RE: Neck Farm 40B Project
13 Neck Road, Lancaster, Massachusetts

NECK
FARM

LAYOUT AND
MATERIALS PLAN

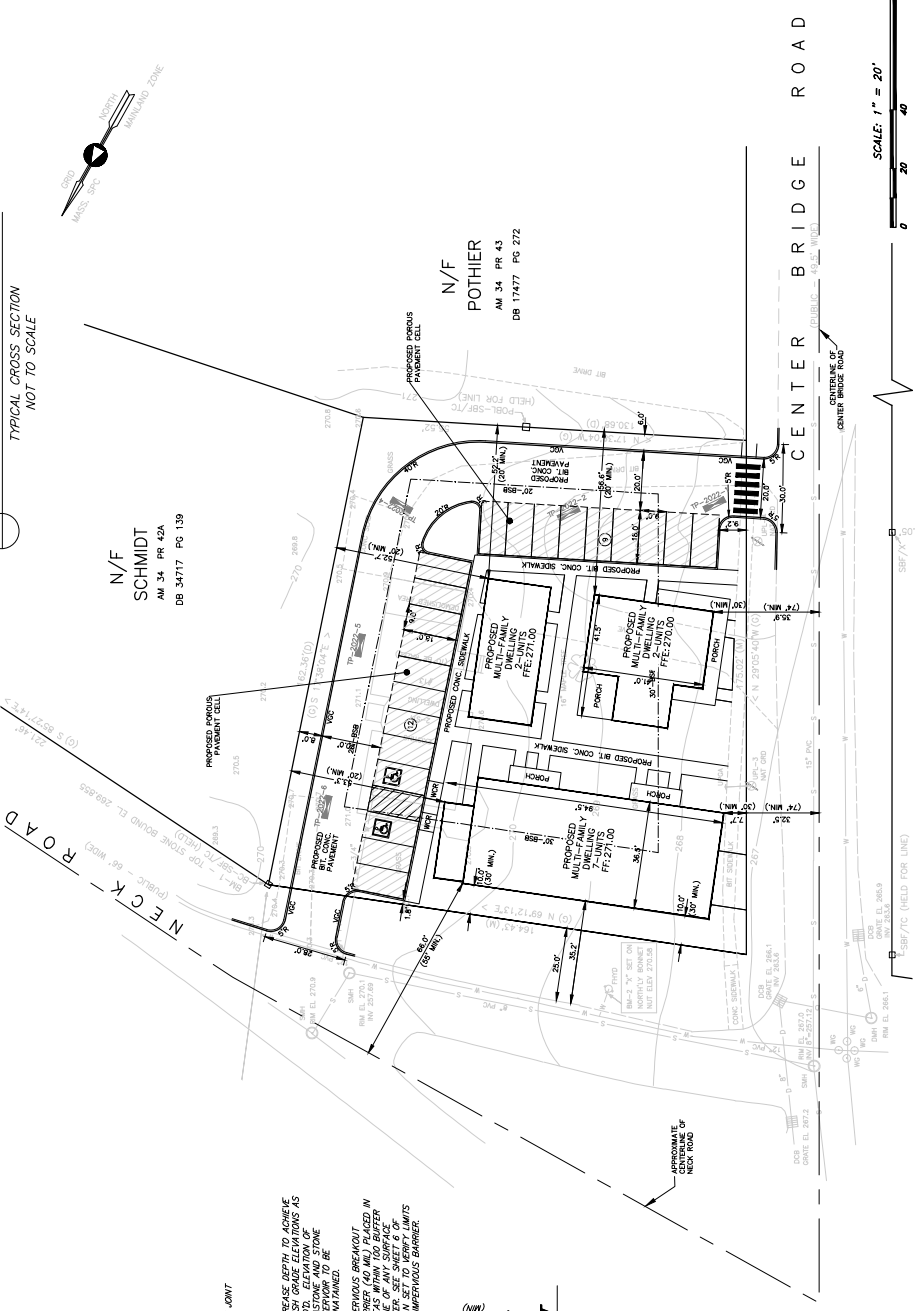
The site plan presented at the meeting showed that the principal building had a westerly front/side setback of 3 feet. The Trust and members of the public expressed concerns about the proximity of the principle building to Neck Road. The Trust wondered if the architectural renderings, which show a landscape buffer between the principal building and the road, reflected the spacing accurately.

In addition, to further address the Trust's input, the applicant has revised the site plan to further move the principal building away from Neck Road. See updated site plan dated April 11, 2023

attached hereto. As shown on the updated site plan, the side/front setback has been increased to 10 feet. With the 25-foot landscaped strip between the property boundary and Neck Road, the principal building will be located approximately 35 feet from the road. We believe this clarification and revision should resolve the Trust's and the public's concerns.
